SEABROOK STATION  
SITE-SPECIFIC OFFSITE RADIOLOGICAL EMERGENCY  
PREPAREDNESS ALERT AND NOTIFICATION SYSTEM  
QUALITY ASSURANCE VERIFICATION

Federal Emergency Management Agency  
Washington, D.C. 20472  
Under Contract No. EMW-83-C-1217

August 30, 1990

FIGURE 5

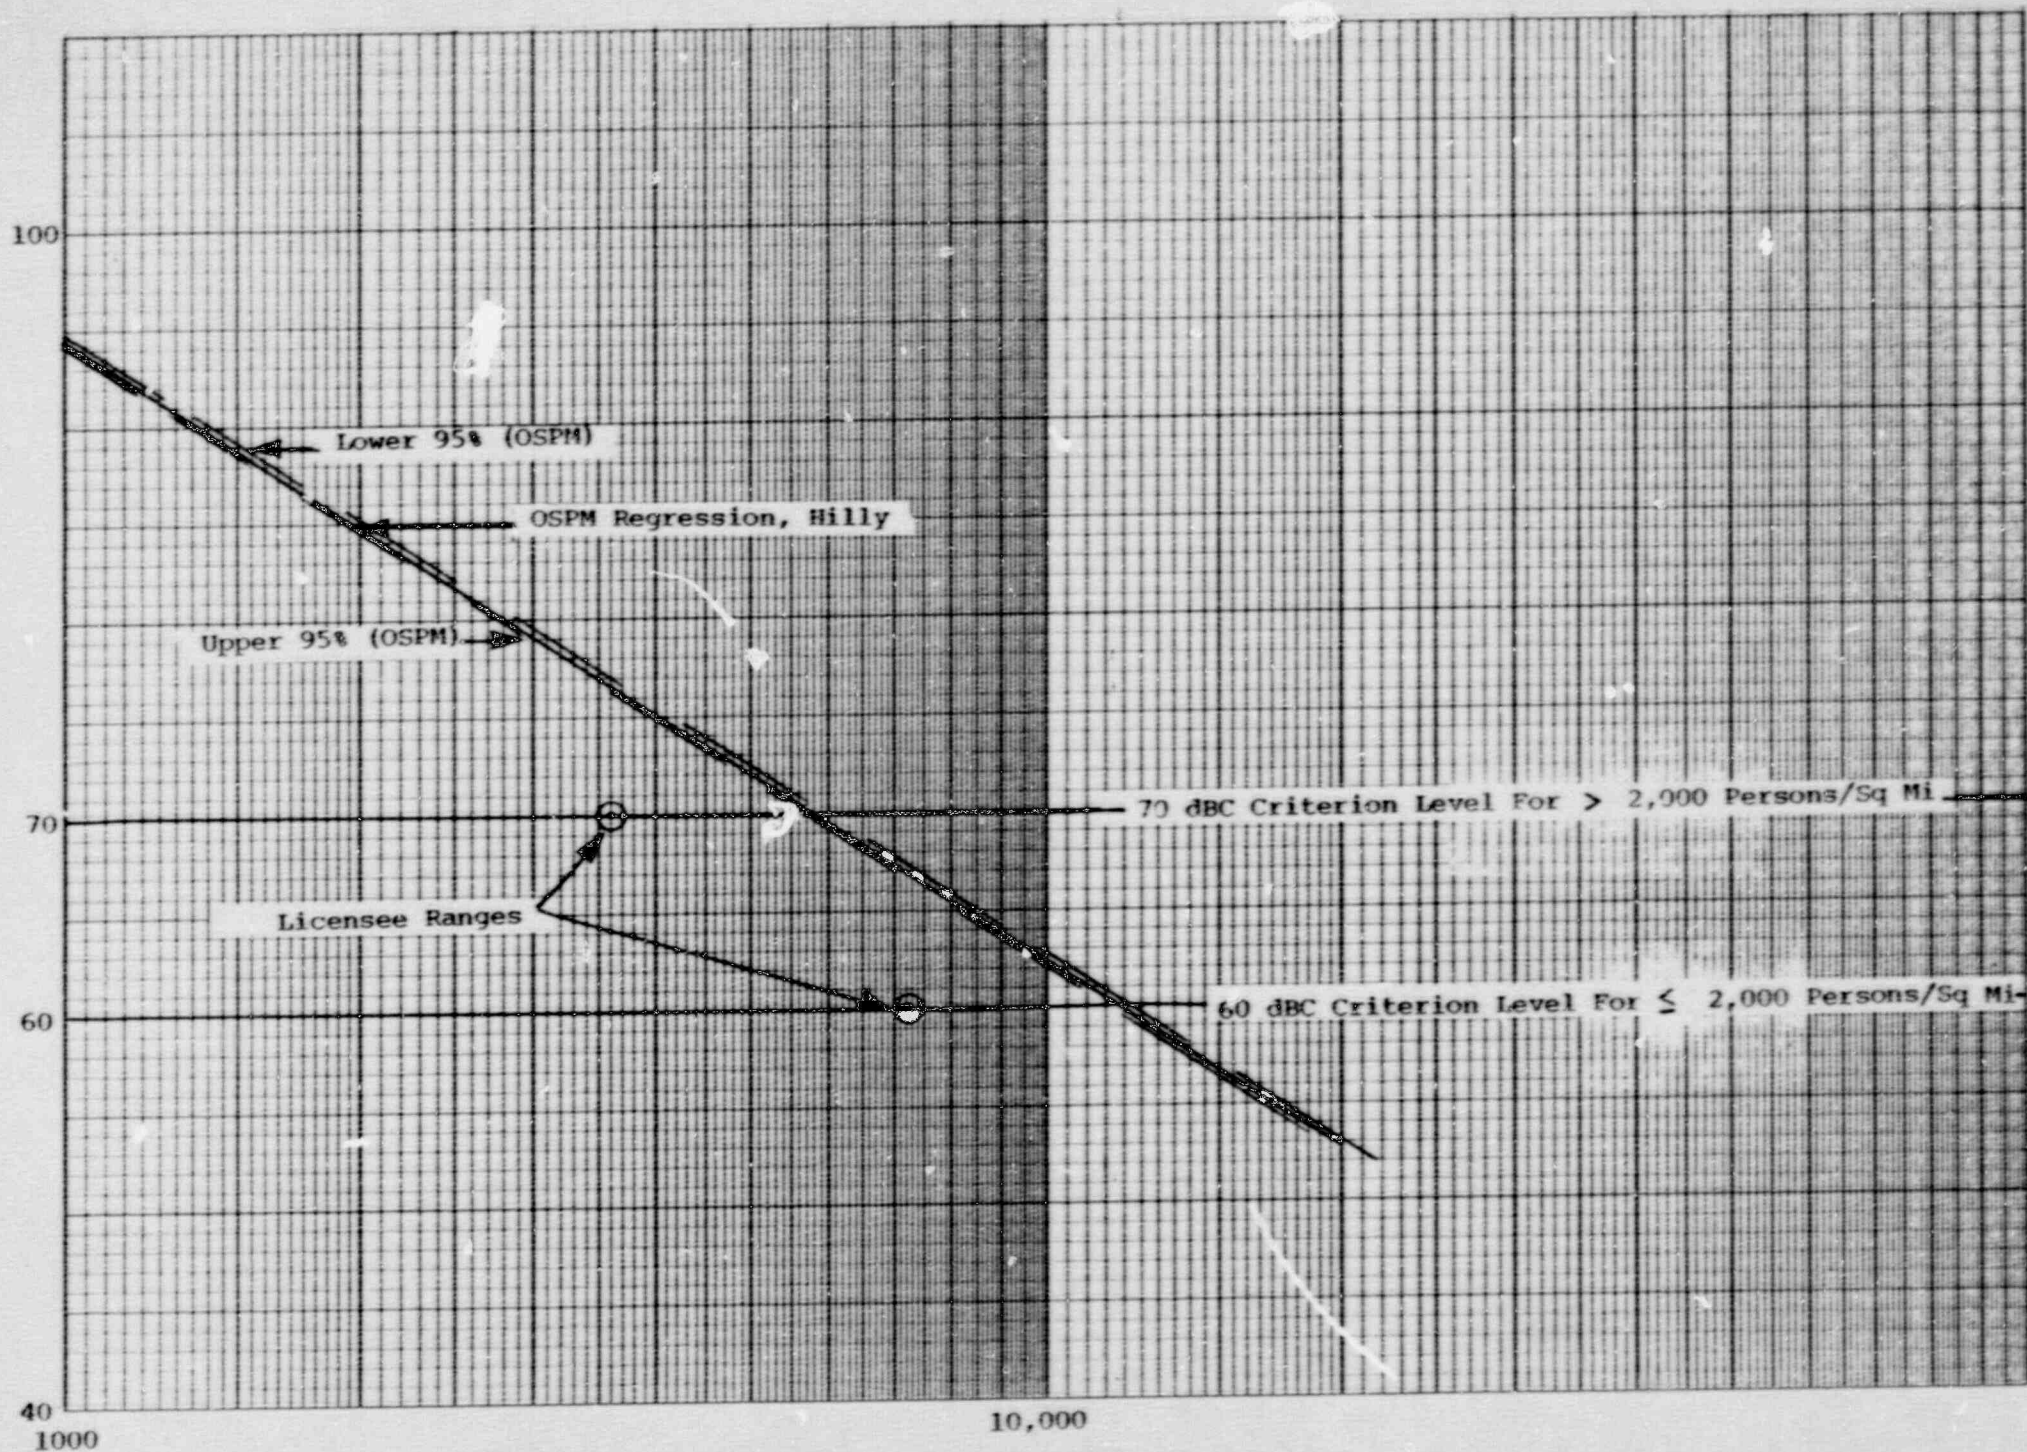
Using field measurements reported in WR 88-9(R) for WS-3000 sirens (for 122 dB at 550 Hz output at 100 feet) of 78.6 dBC at 4,100 feet and 65.5 dB at 10,000 feet (the lower range of measurements), it can be seen from Figure 5

that the OSPM estimated sound levels are closer (75 and 62 dBC) to the measured levels than either the 10 dB rule (68 and 56 dBC) or the licensee's predictions (64.8 dBC and 43.9 dBC). The measured siren sound levels for the WS-4000 siren were 84 dBC at 4,100 feet, 67 dBC at 10,000 feet; OSPM regressed values at corresponding distances were 81 dBC and 68 dBC respectively whereas the 10 dB rule would have resulted in 73 dBC and 61 dBC and the licensee's predictions would be 75 dBC and 61 dBC. The measured level for the VANS was 70 dBC at 10,000 feet; compared to the OSPM prediction of 70.5 dBC for flat terrain, 69 dBC for a slightly obstructed path, and 67 dBC predicted by both the 10 dB per distance doubling rule and licensee's estimate.
